SUBJECT: Withdrawal of Department of the Army Permit Application SWG-2018-

00789

AXIS MIDSTREAM HOLDINGS, LLC MIDWAY to HARBOR ISLAND PROJECT Proposed Pipelines & Facilities

PERMIT APPLICATION SWG-2018-00789 AXIS MIDSTREAM HOLDINGS, LLC

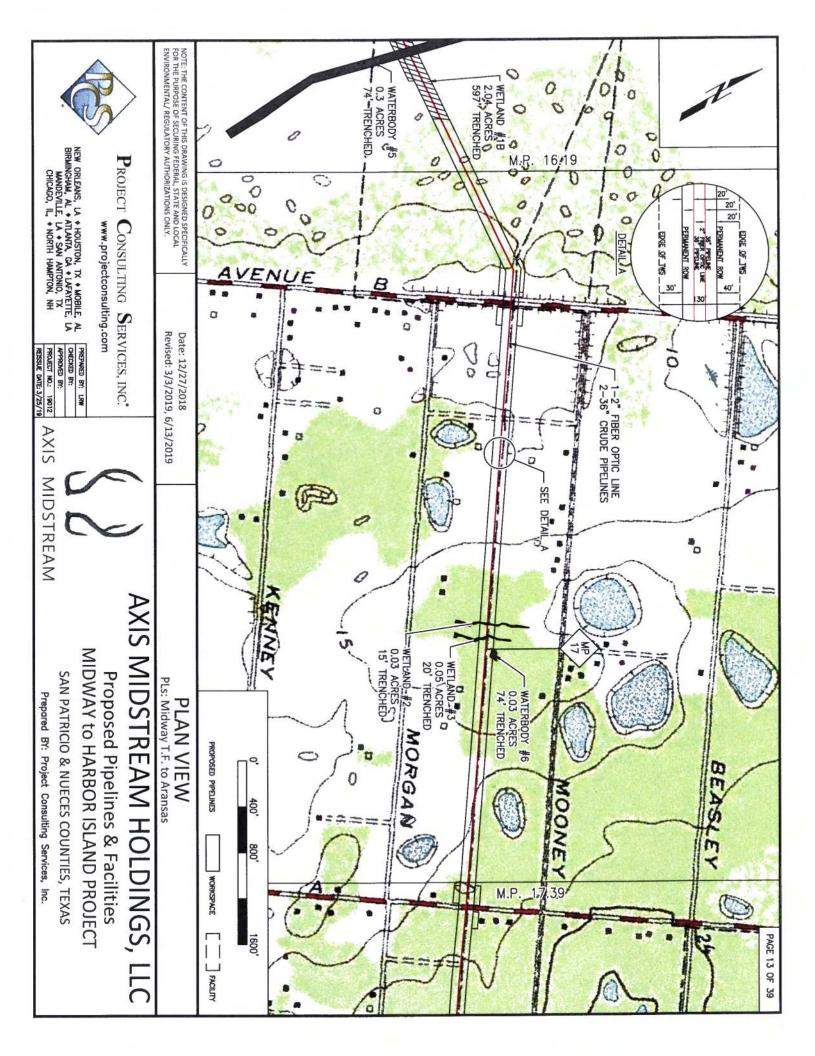
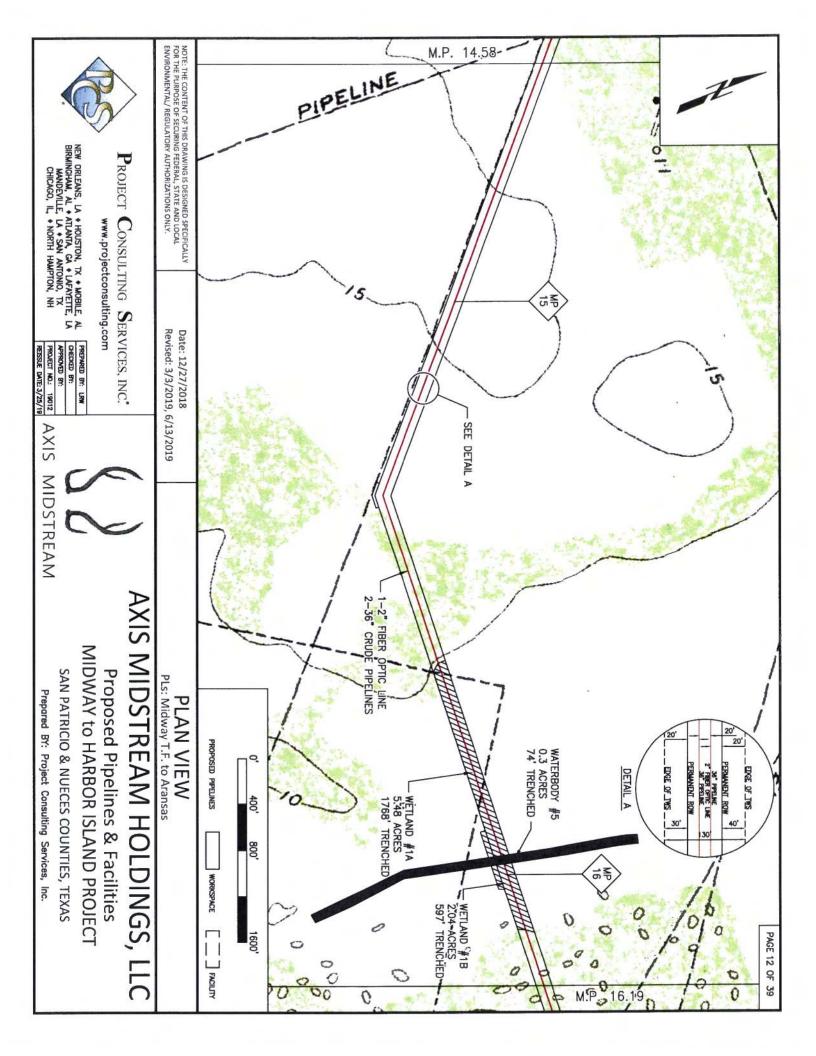
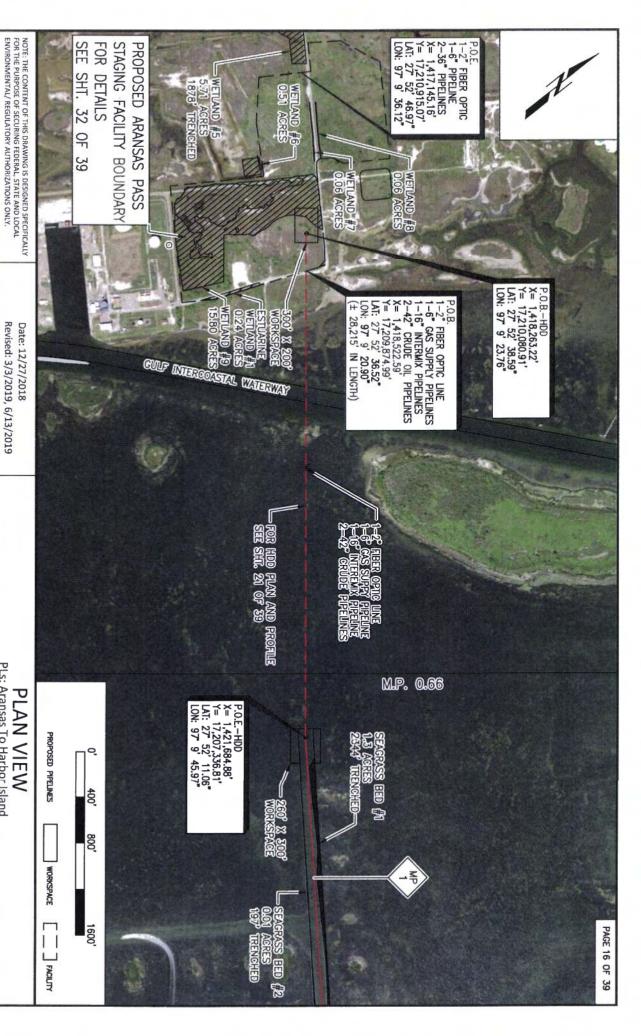
Bob, can you revise the coordinates on the PJD Table:

- 1) DD/mm/ss to Decimal Degrees
- 2) UTM Columns: Typically, a UTM Northing is 6 digits and an Easting is 7 digits. There is an extra digit on each number. Please review that and double check to make sure my eyesight is not headed south lol. Ifs its incorrect, revise that as well to reflect UTM Zone 14R NAD83

You know what, I bet those UTM coordinates are in US feet. I need them in meters if that is the issue.

Pursuant your e-mail request, attached please find the updated PJD table for the Axis - Midway to Harbor Island Project (SWG-2018-00789). Please let me know if you have any questions. Thanks!
